9 April 2026
317819

RE: Submission on Amendment C109moor Merrimu PSP

MERRIMU PRECINCT STRUCTURE PLAN – STORMWATER CONSIDERATIONS

Merrimu Native Vegetation Precinct Plan: Impact and Offset Review

Figure 2 Proposed catchment redistribution and wetland layout – WL01

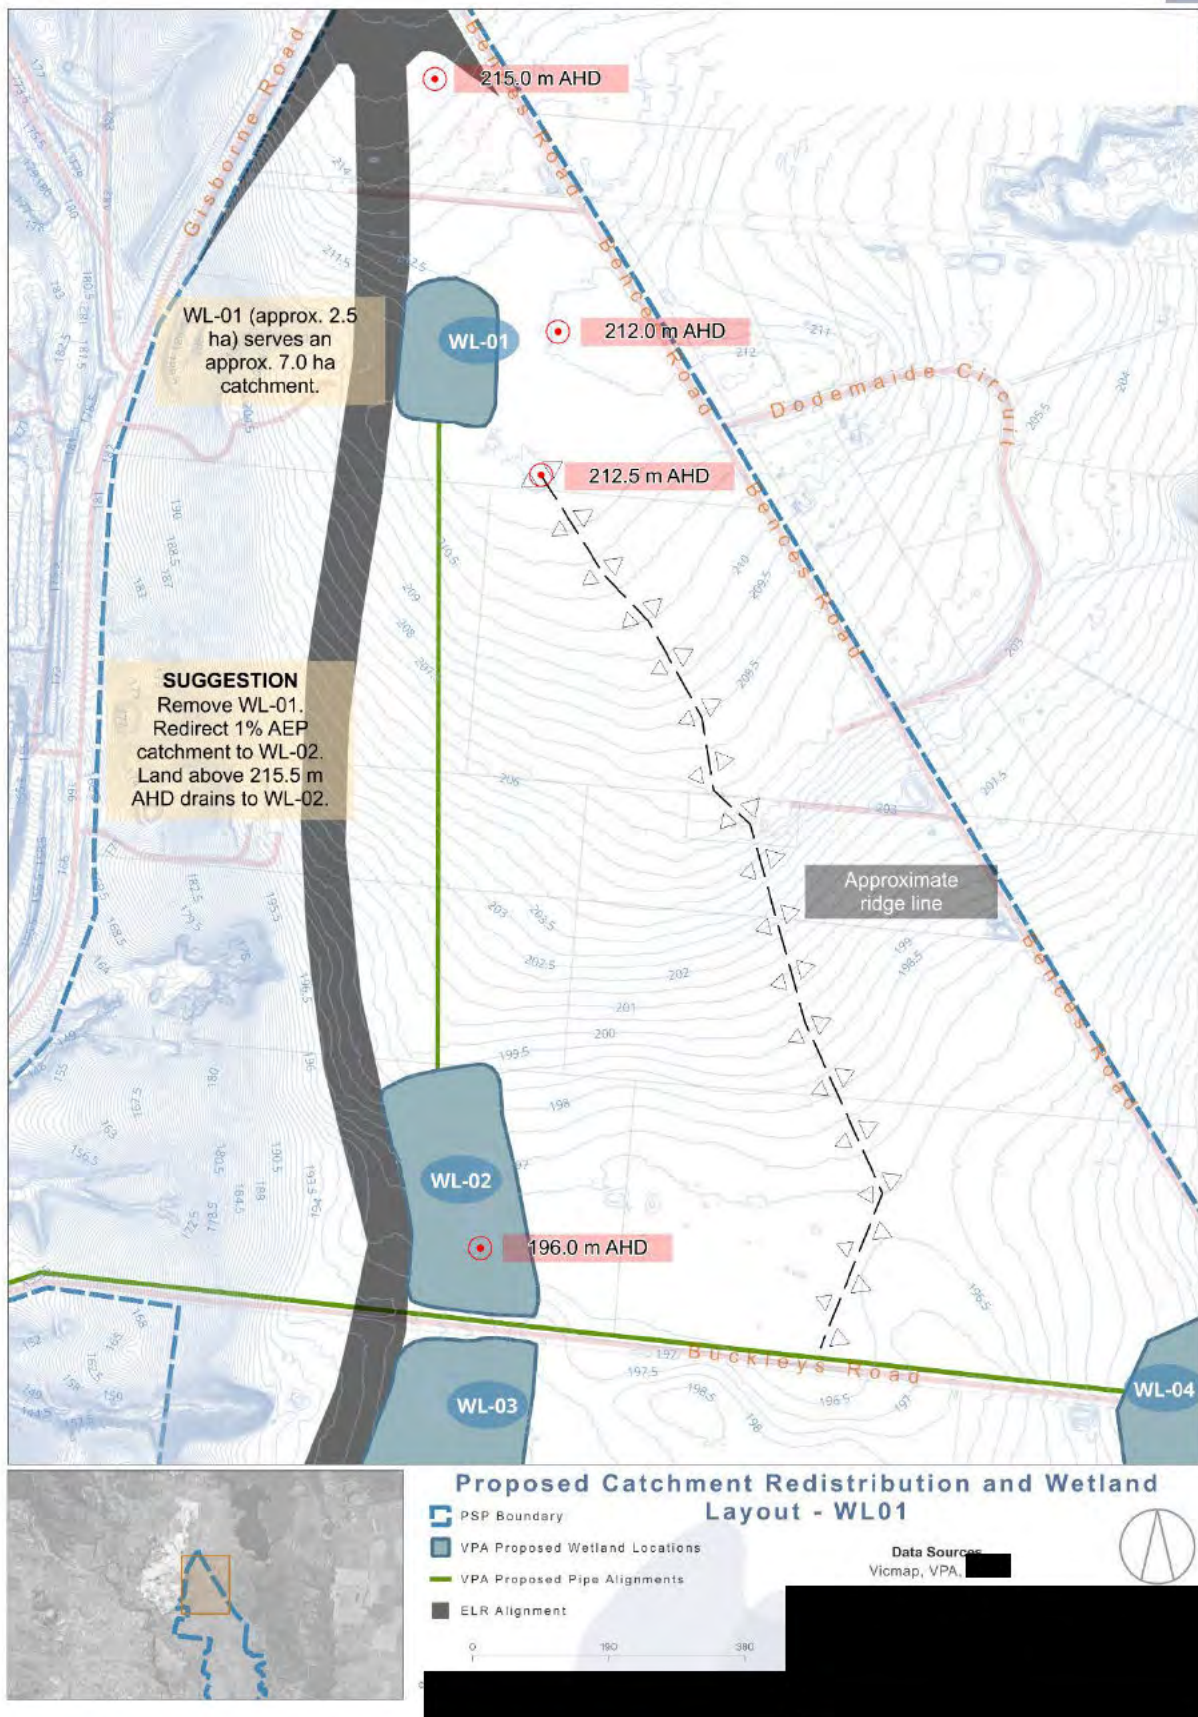
It is requested that WL-01 be removed with all catchment area north of Buckleys Road and west of the ridge line (as shown in Figure 2

Figure 3 WL-05 in relation to 184.0 m AHD contour

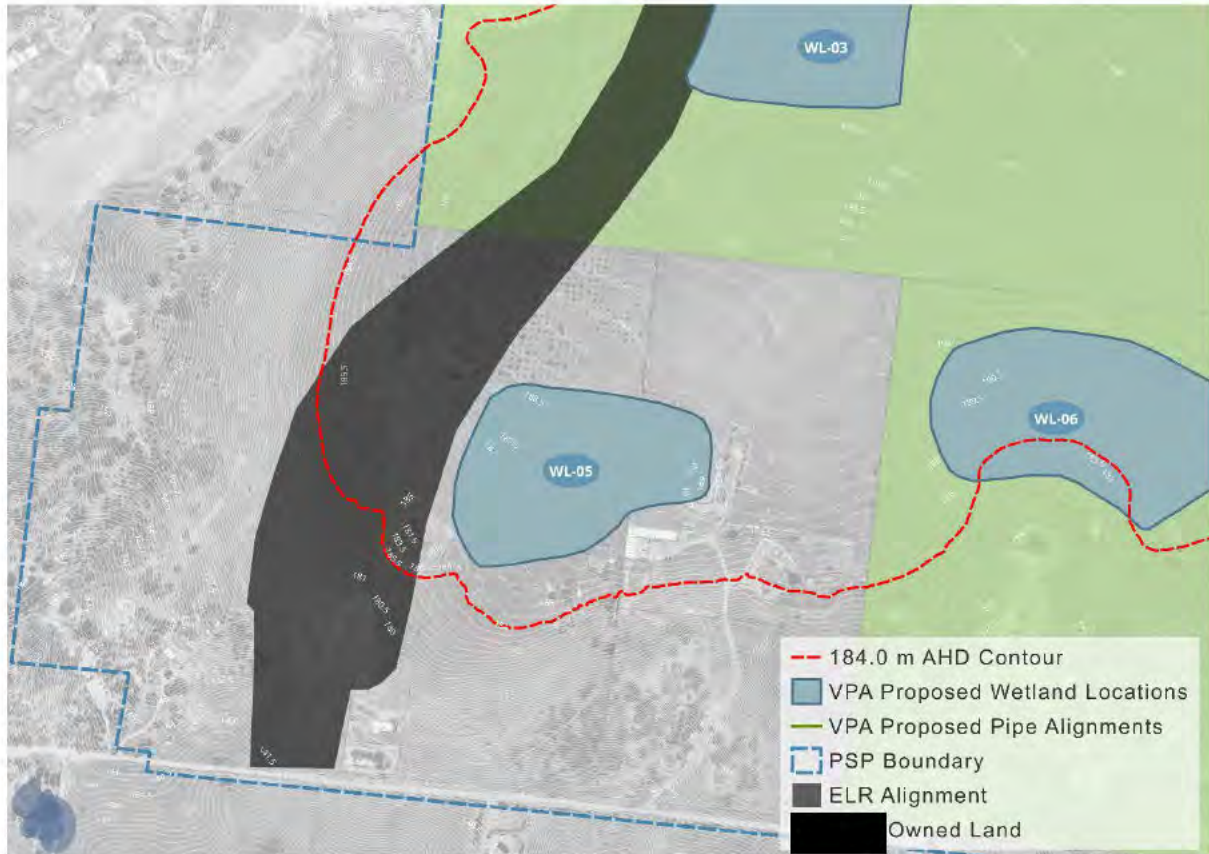
█ is generally comfortable with the location of the proposed WL05. It is requested that the ultimate downstream side of the footprint be located slightly south of the location shown by the VPA, closer to the 184.0 m AHD contour as shown in Figure 3.

Figure 4 WL-06 in relation to existing dam

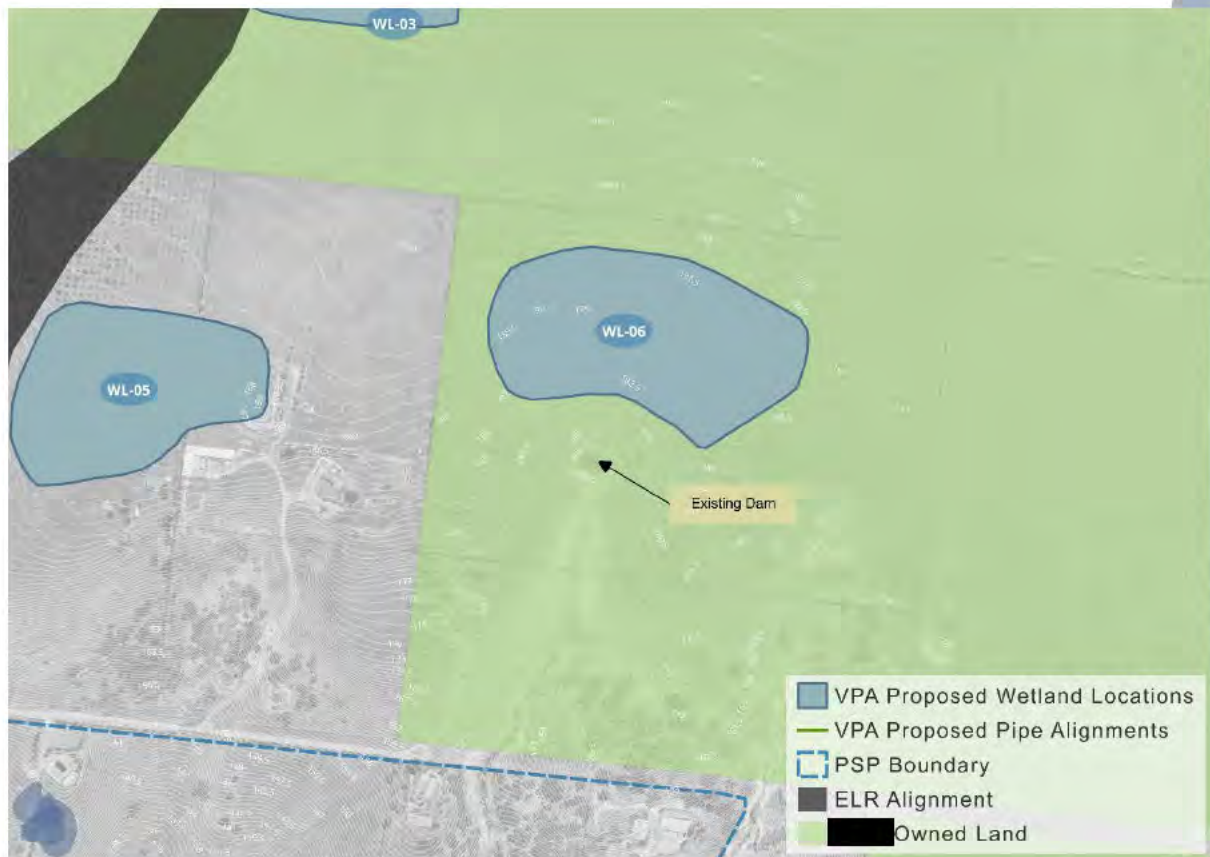
█ is generally comfortable with the location of the proposed WL06. It is requested that the ultimate downstream side of the footprint be located slightly south of the location shown by the VPA, closer to the existing dam as shown in Figure 4.

Figure 5 WL07 – Proposal to retain

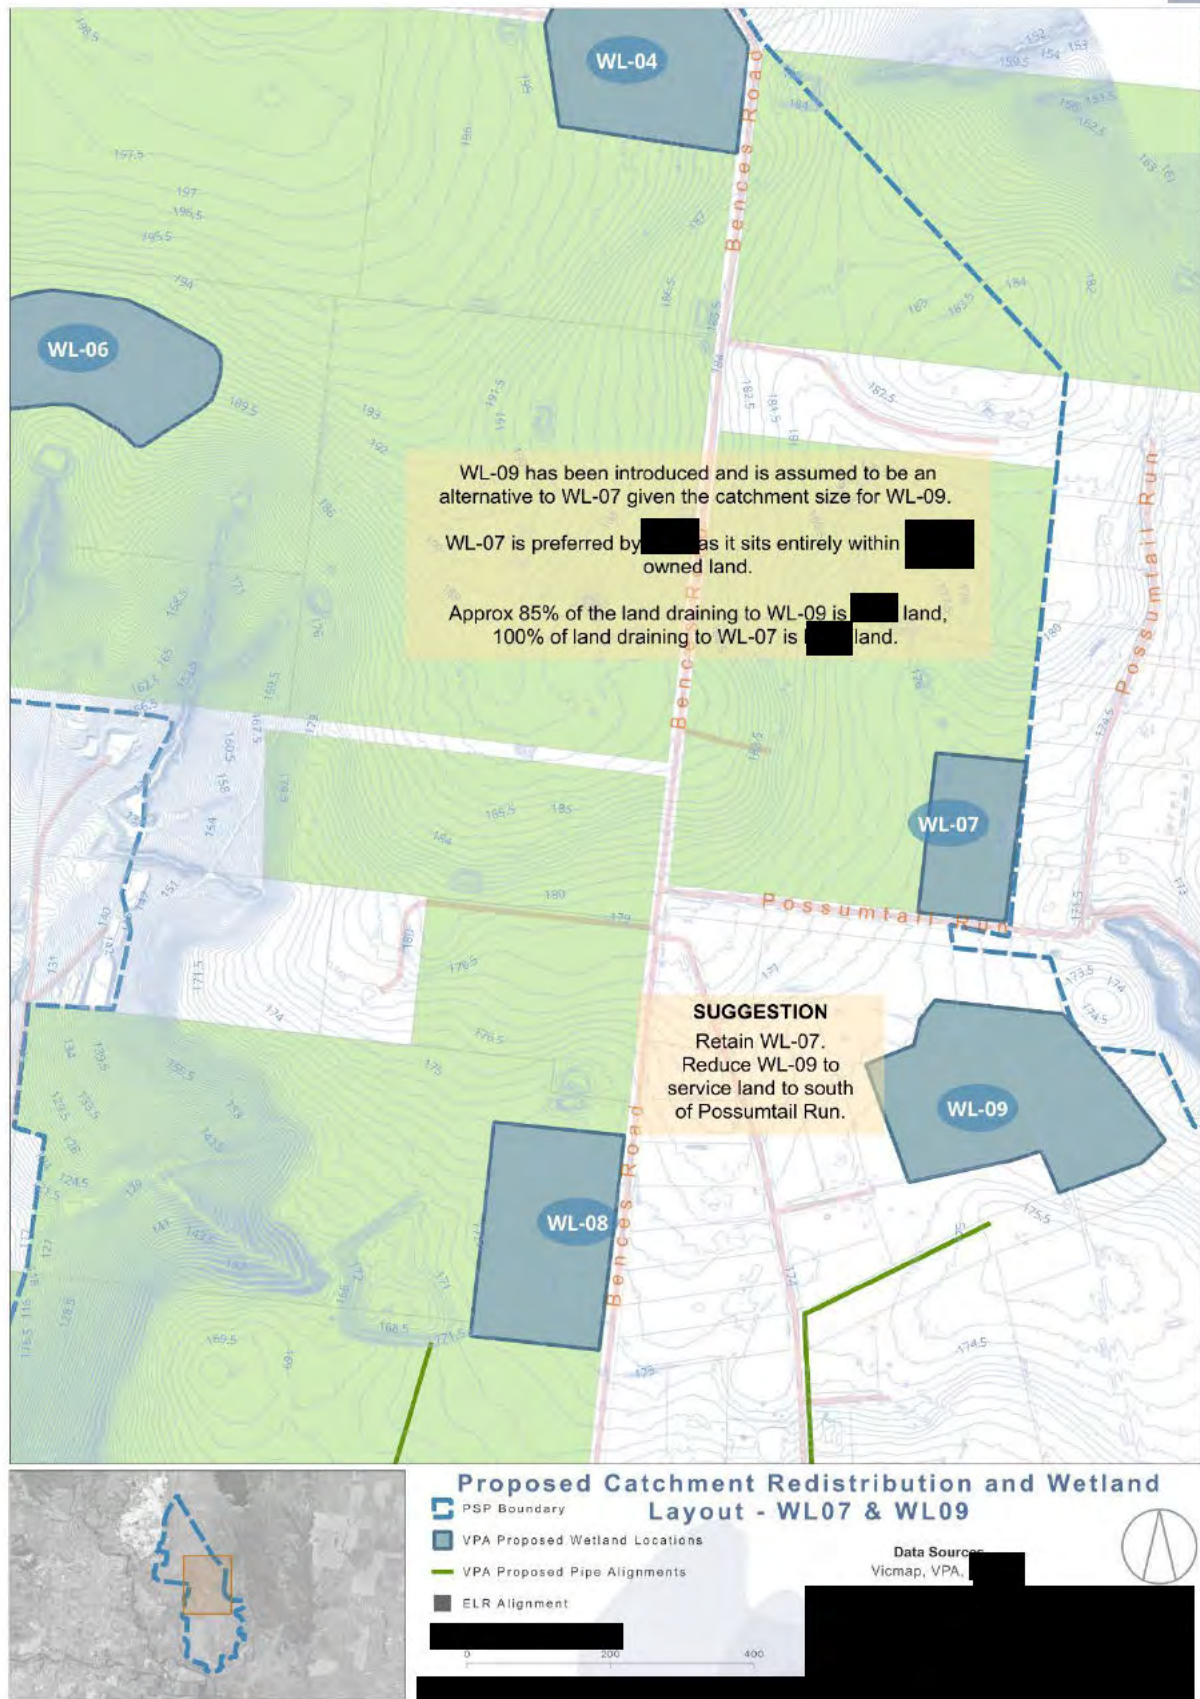
WL07 and WL09 are located in close proximity to each other. From the catchment that would drain to WL07, 100% is owned by BMD. If WL07 were to be removed, and the land drain to WL09, around 85% of the land draining to it would be BMD owned.

It is requested that WL07 is retained and solely services the [redacted] land to its north and north-west as shown in Figure 5. This would likely result in a smaller WL09 being required for the land to the south, although this has not been investigated further.

Figure 6 Proposed relocation of WL08

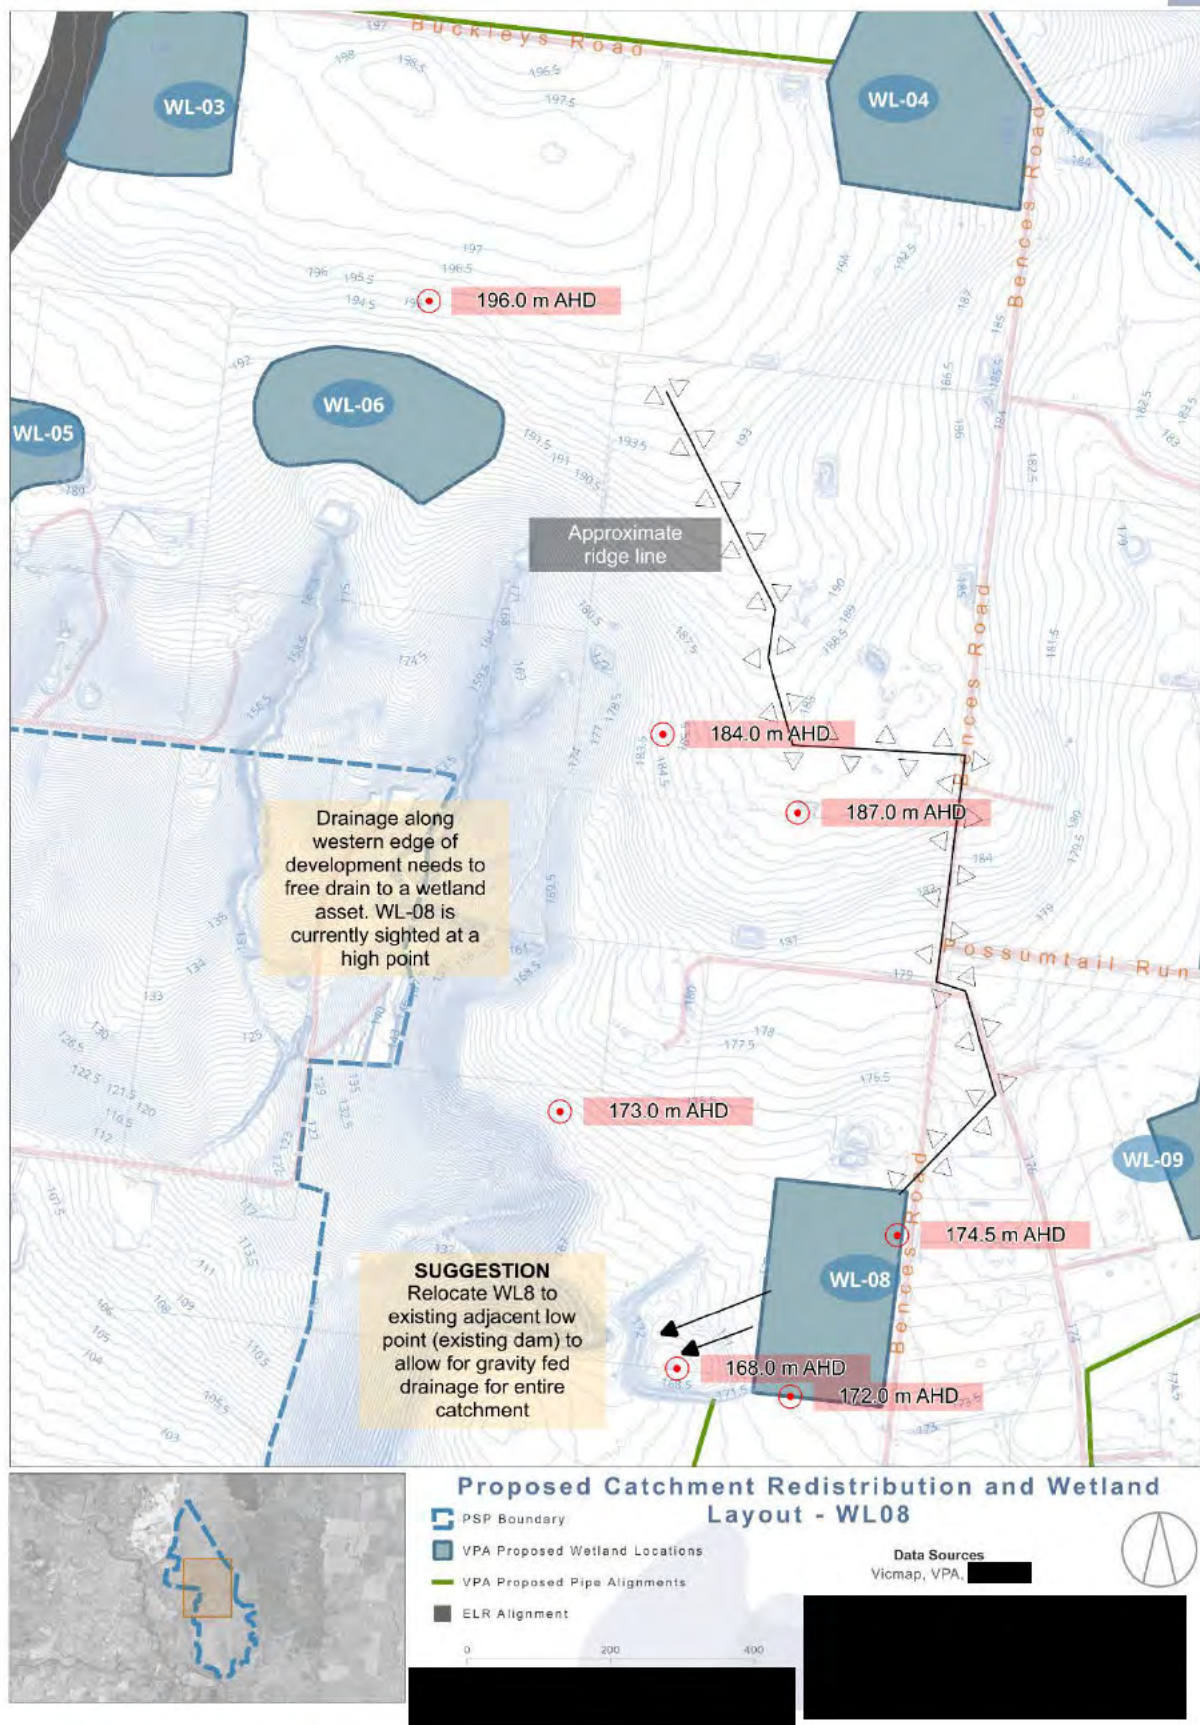
████ is generally comfortable with the location of the proposed WL08. It is however requested that the asset is moved in a south-westerly direction towards the existing dam, as shown in Figure 6.

Figure 7 WL-12 Relocation

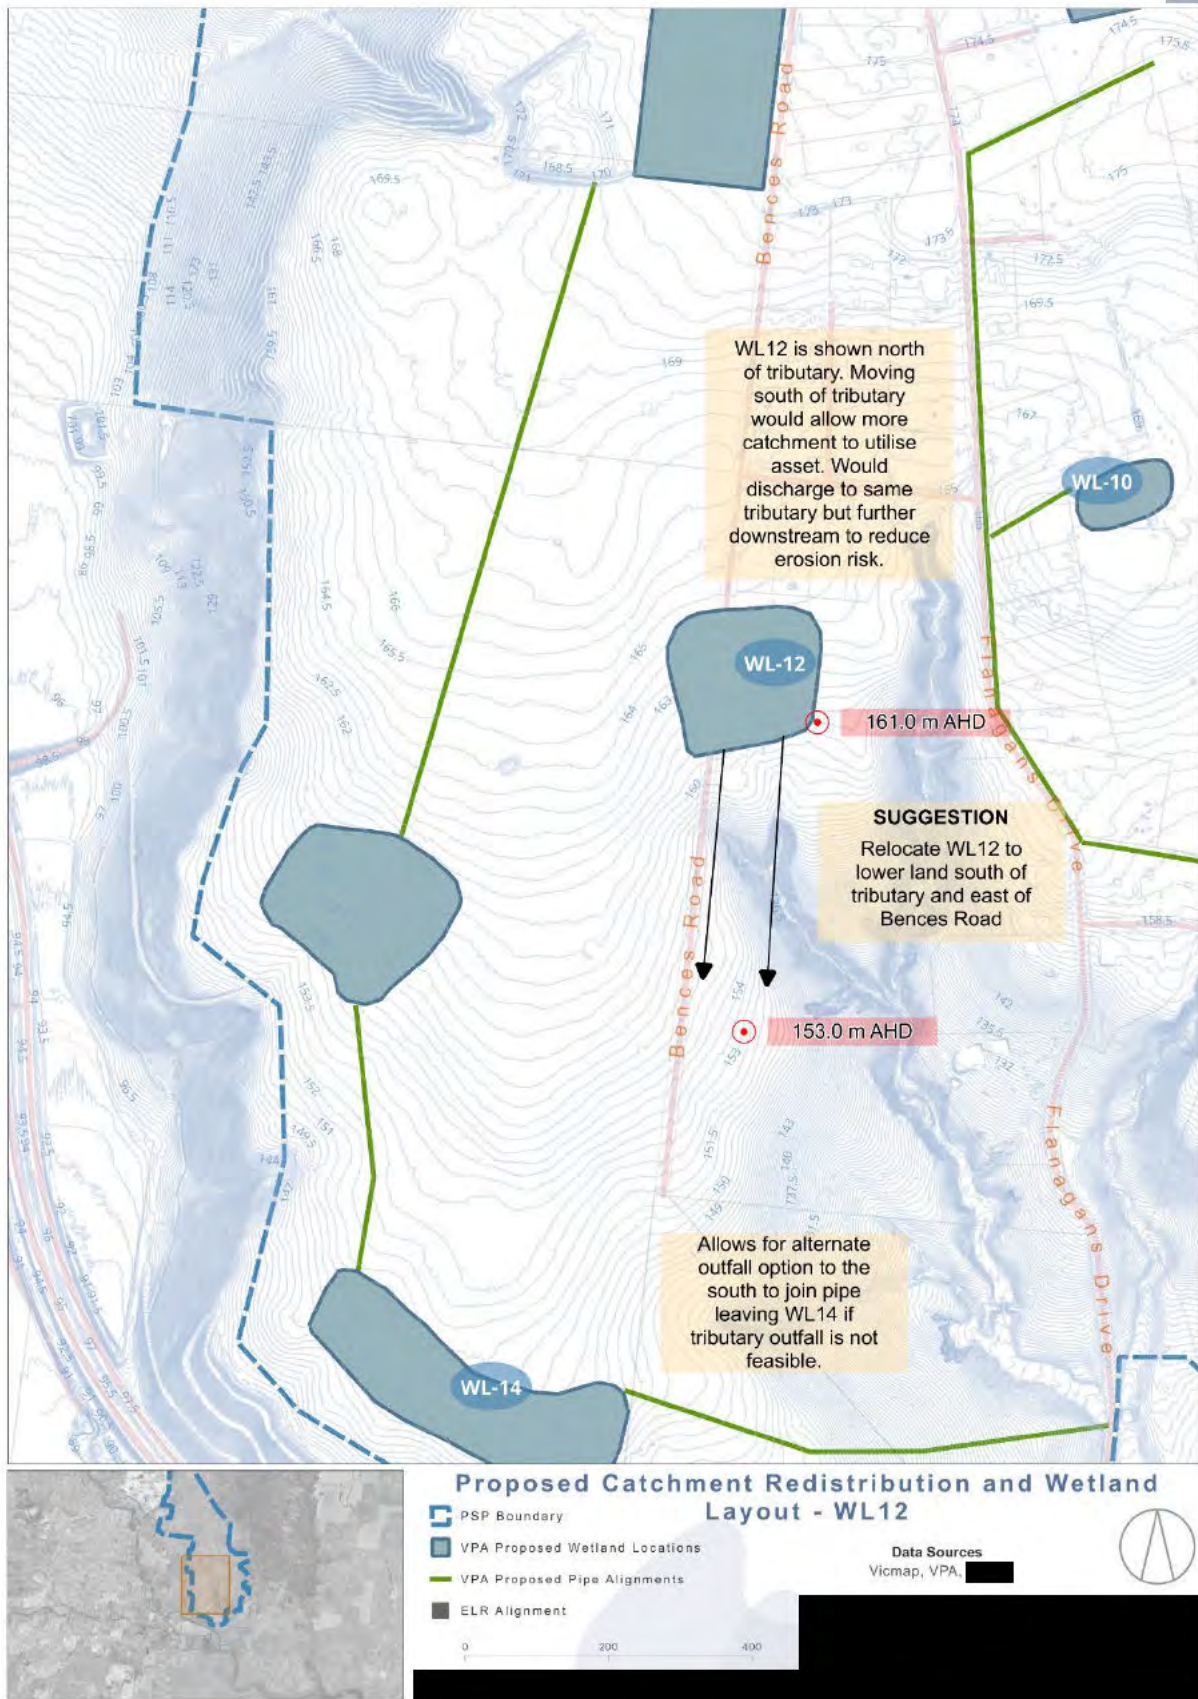
WL12 is not within █████ land, although █████ have been asked to comment on its location and suitability in agreement with the land-owner.

It is suggested that WL12 could be moved further south to the southern side of the existing tributary as shown in Figure 7. This would allow a larger catchment to drain to the asset and would also provide alternate outfall option (to the south to combine with the WL-14 outfall). It is suggested that the ultimate footprint should sit on the eastern side of Bences Road.
